BROAD AGENCY ANNOUNCEMENT (BAA)

High Power Solid State Circuit Protection for Power Distribution and Energy Storage

The purpose of this amendment is to: 1) Respond to questions submitted from 7 JUN 2013 to 27 JUN 2013; and 2) Make revisions to the BAA as a result of questions and answers.

ONR BAA Announcement # ONRBAA13-016
Amendment 0002

Figure 2. Notional Energy Magazine Mission Load Interface for single and multiple loads

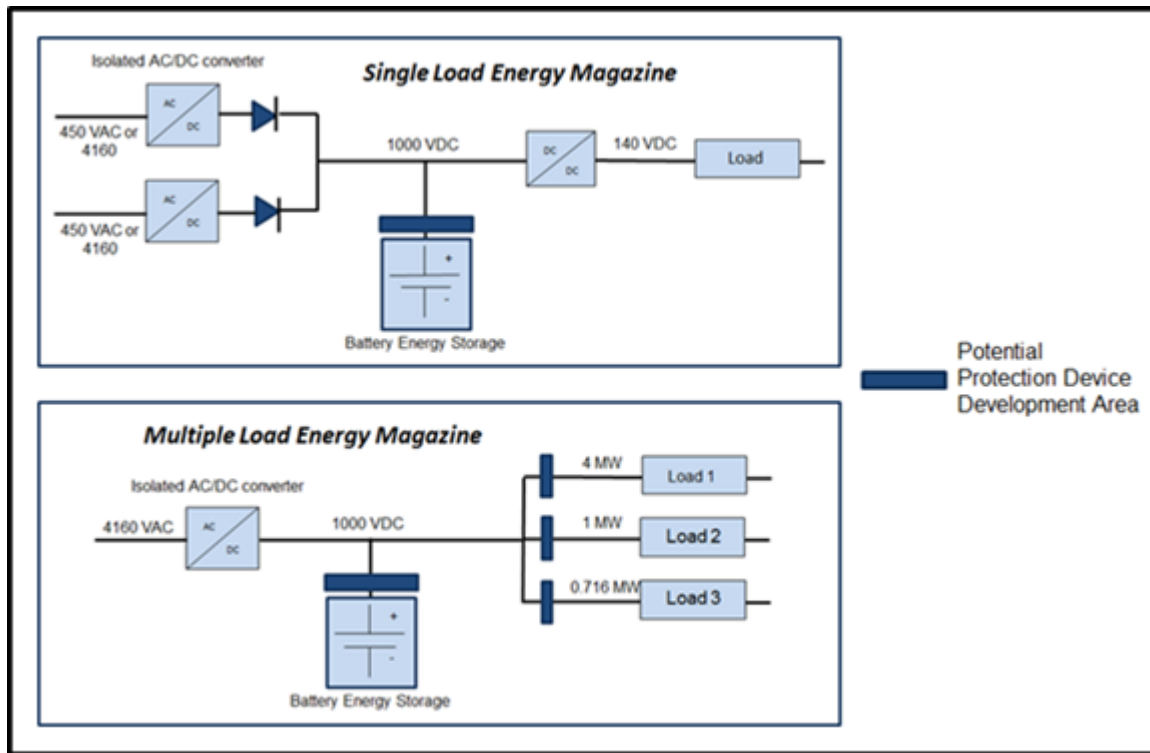
Question 13: Is the source impedance during fault for the various sources been determined? If yes what is it for the various sources listed?

Answer 13: Referring the Figure 2 of the BAA, proposers are expected to make a best case engineering estimate of the network impedance based on the enumerated loads.
